Proposed Revisions to a Standard Plans Index

Index Number: 455-031

Index Title: 30" SQUARE PRESTRESSED CONCRETE PILE -
HIGH MOMENT CAPACITY

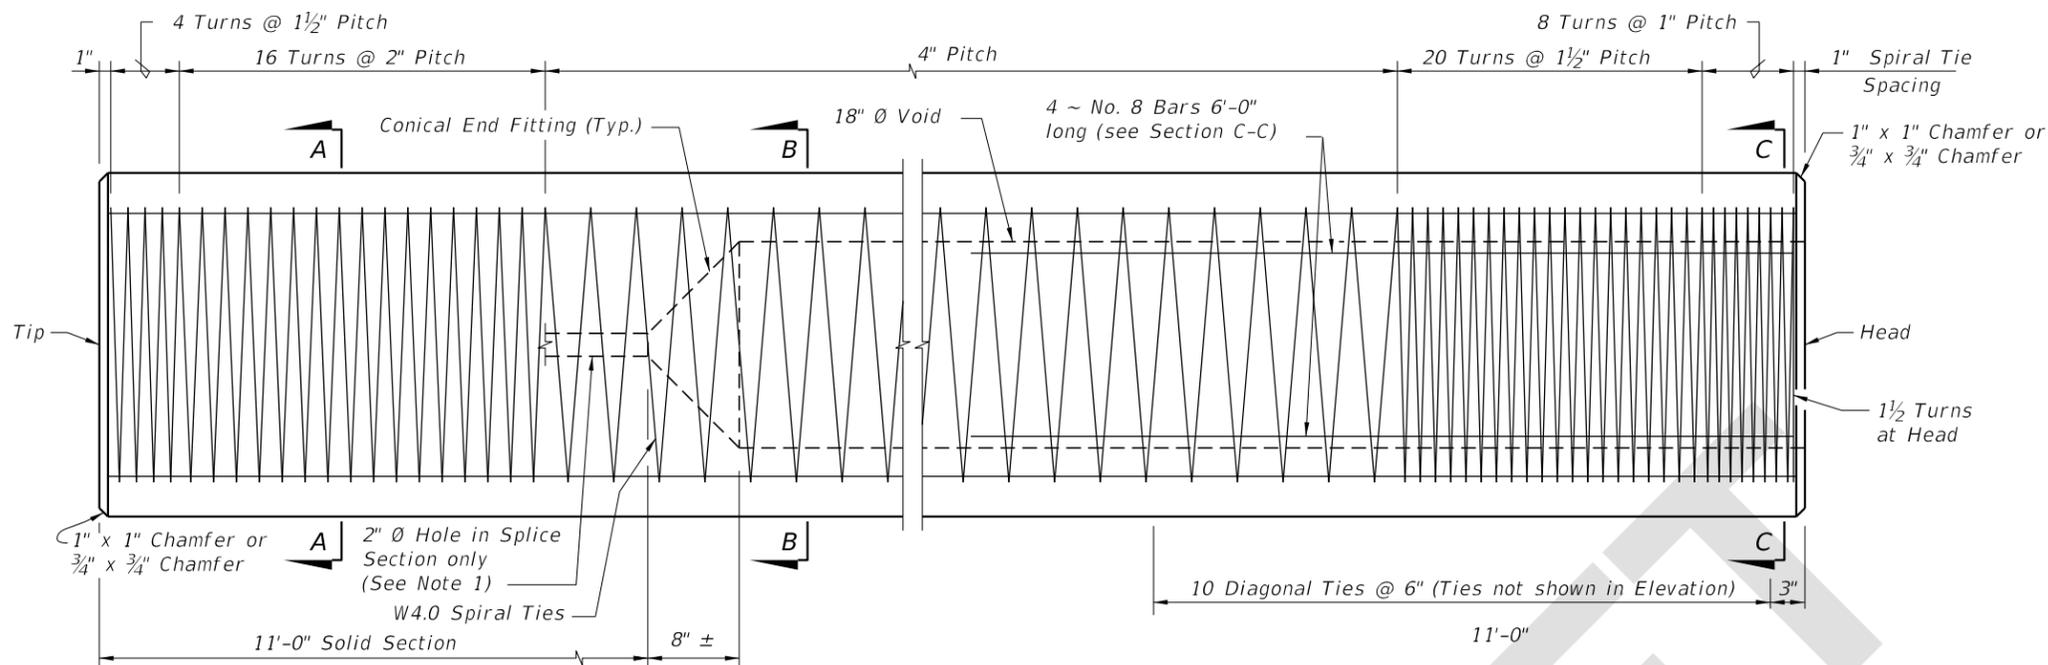
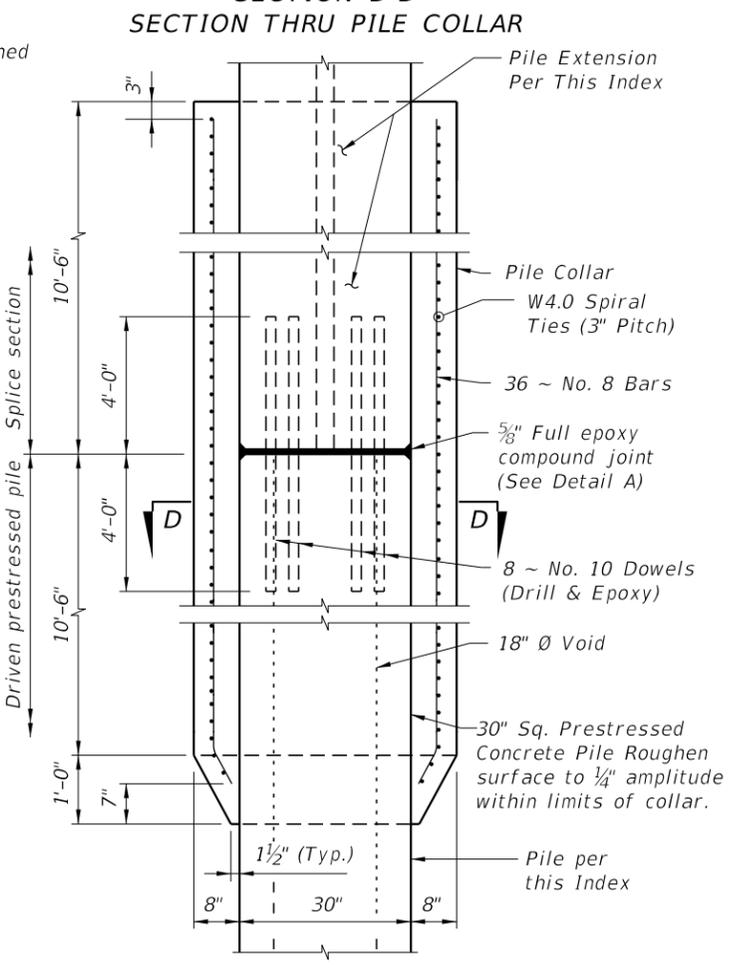
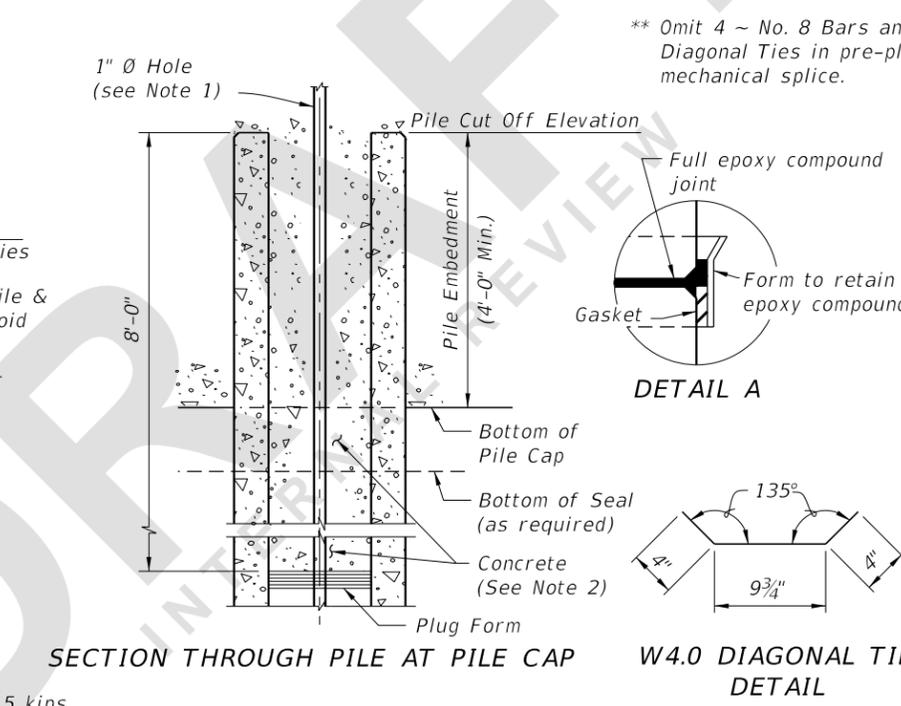
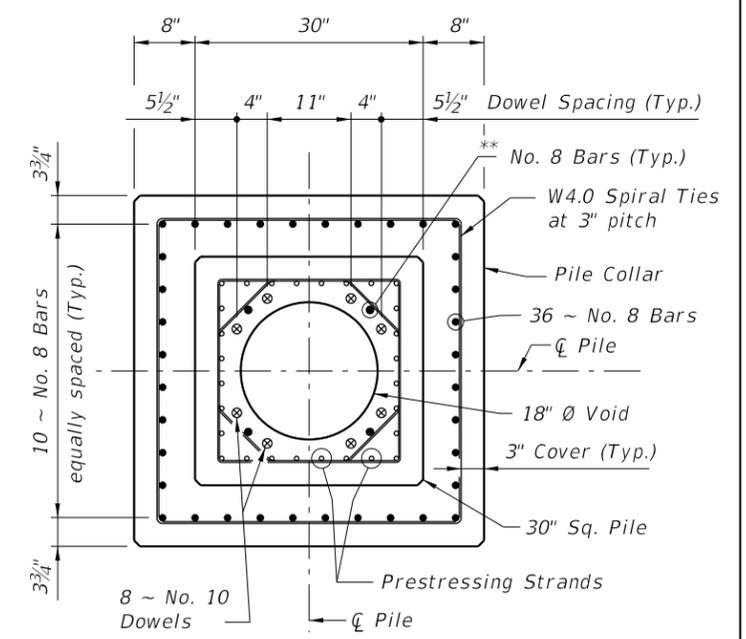
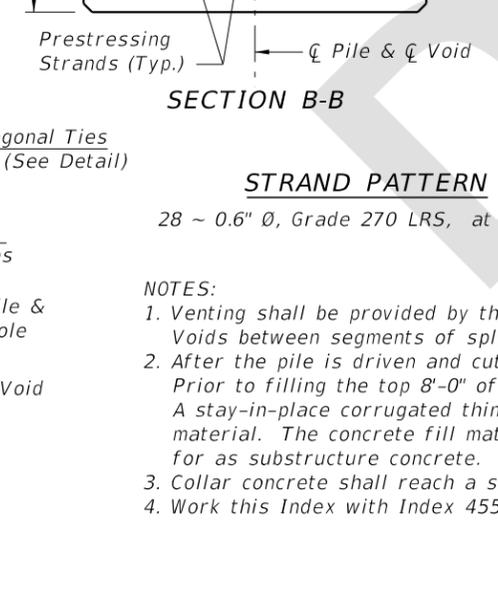
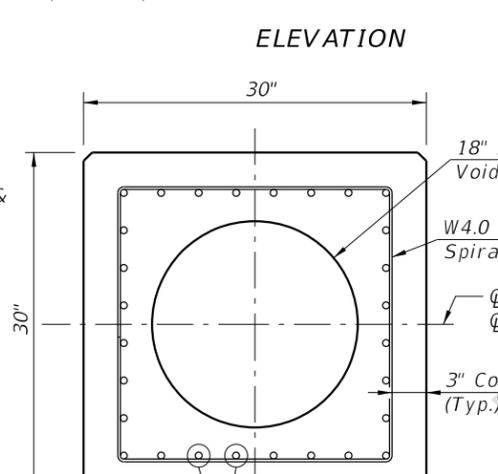
Reverted to the previous version of the Standard.
